Laundry room — zone by zone

Current condition matched to the proposed enhancement, area by area

Seven zones identified from the walkthrough video and the site photographs. Each is paired with the concept render that shows its target condition, the specific interventions that apply to it, and where it sits in the four-tier budget.

Entry wall, 0:00–0:02 in the walkthrough

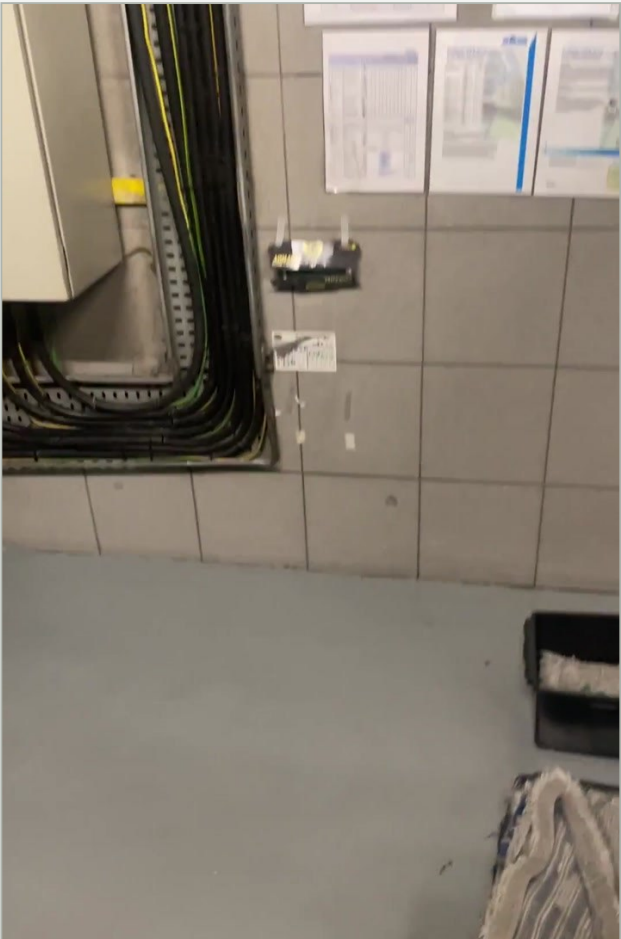
- A distribution board with heavy cabling entering, and roughly fifteen A4 sheets taped to the tile directly beside it.
- Open lint trays, a woven sack and a plastic storage box on the floor beneath the board.
- No keep-clear zone marked or maintained in front of the board.

- Strip the paper wall entirely. Combustible material does not belong against a live board.
- Clear the floor beneath and in front of it, then paint a keep-clear zone on the resin.
- Replace the paper with the printed kit: one KEEP CLEAR — ELECTRICAL PANEL sign at a fixed height.
- Documents move to the framed DAILY CHECKS board in the alcove (Zone 03).
